We have completed a preliminary review of your application requesting a source material license for a research and development in-situ uranium recovery facility in Converse County, Wyoming, and have accepted it for further processing. Docket No. 40-8786 has been assigned to this case and should be referred to in all future correspondence.

1. Questions
2. Requests for Additional Information - URI

Solution Mining R&D Project

FIGURE C-4-4a

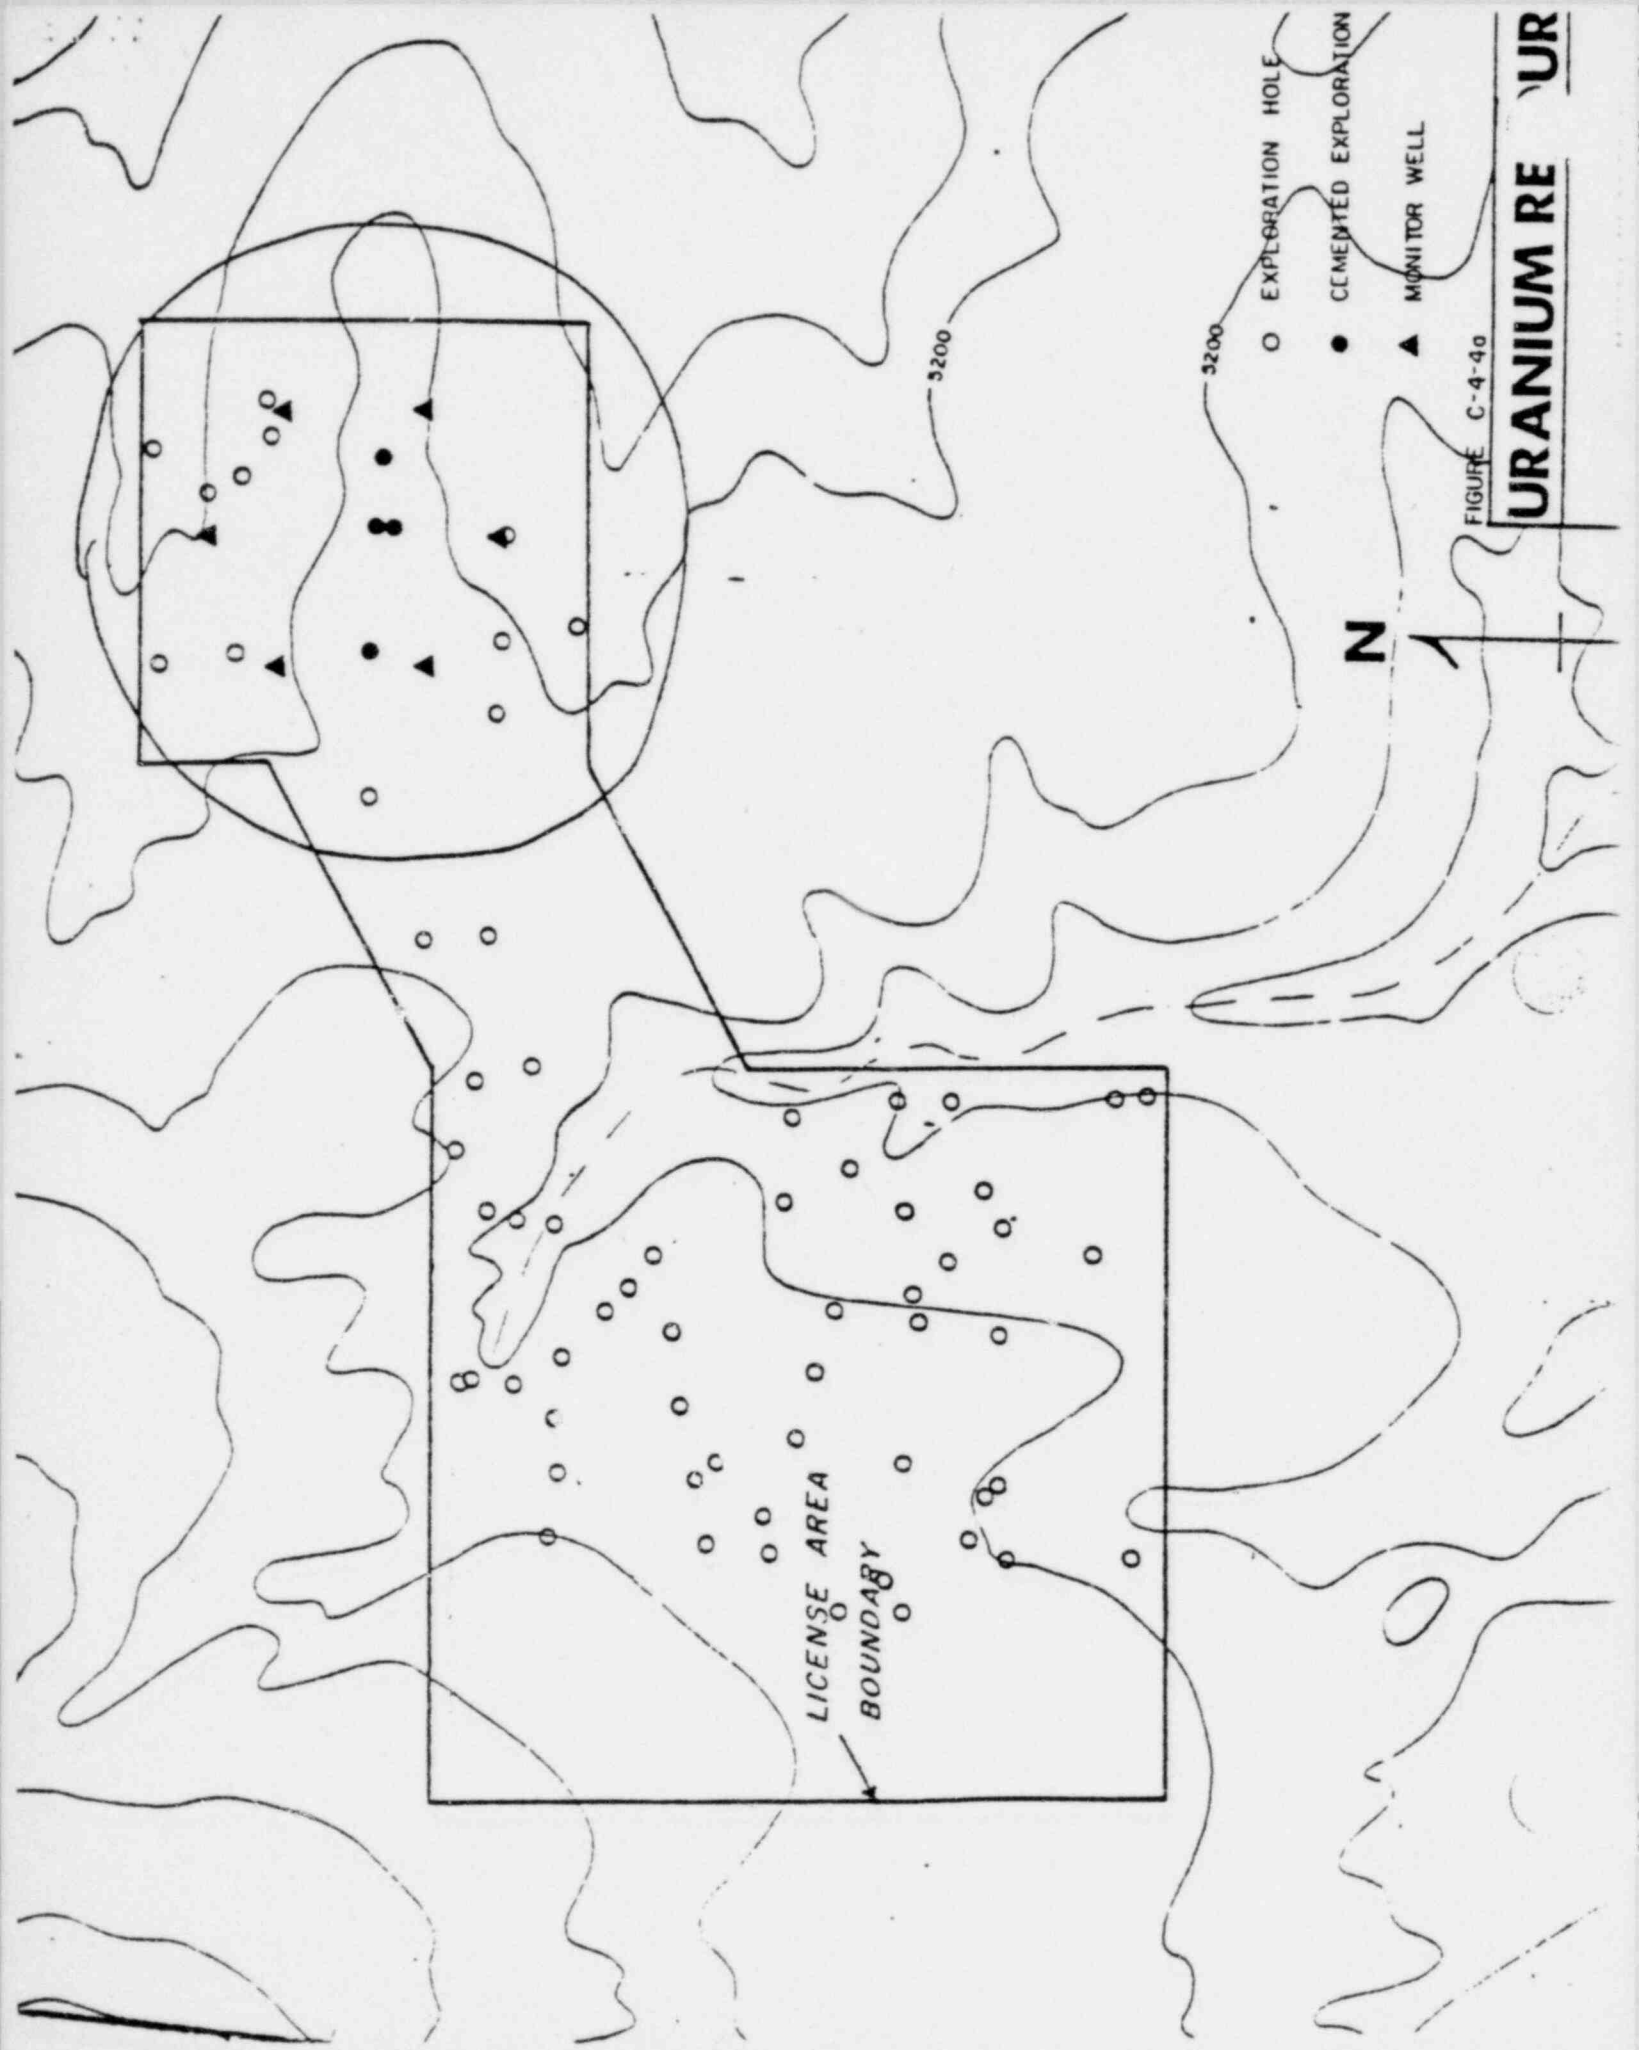
1. Approximately 65 exploratory borings are shown in Figure C-4a. It is necessary to number these holes on the diagram and to indicate which is a core sample hole, a geophysical hole or both.

2. Copies of all lithologic core sample logs for the exploratory holes in the circled area from Figure C-4-4a should be provided. For these core logs the following information is needed: (1) The hole # from the location map; (2) Observations made during drilling; (3) Thickness of the overburden; (4) Elevation top of rock and bottom of the holes; (5) Total footage of rock drilled; (6) Casing through the overburden, details of how it's set and elevations; (7) Total length of core material actually recovered and the diameter; (8) Total core loss (these locations should be marked on the logs); (9) A scale with detail such as 1" = 10' to 1" = 1'; (10) Date started and finished; (11) Lithologic symbols; (12) Log or horizontal and vertical fractures; (13) Lithologic description corresponding to the log of vertical and horizontal fractures; (14) It is expected as is common practice that this information will shown on adjacent columns of the same log sheet.
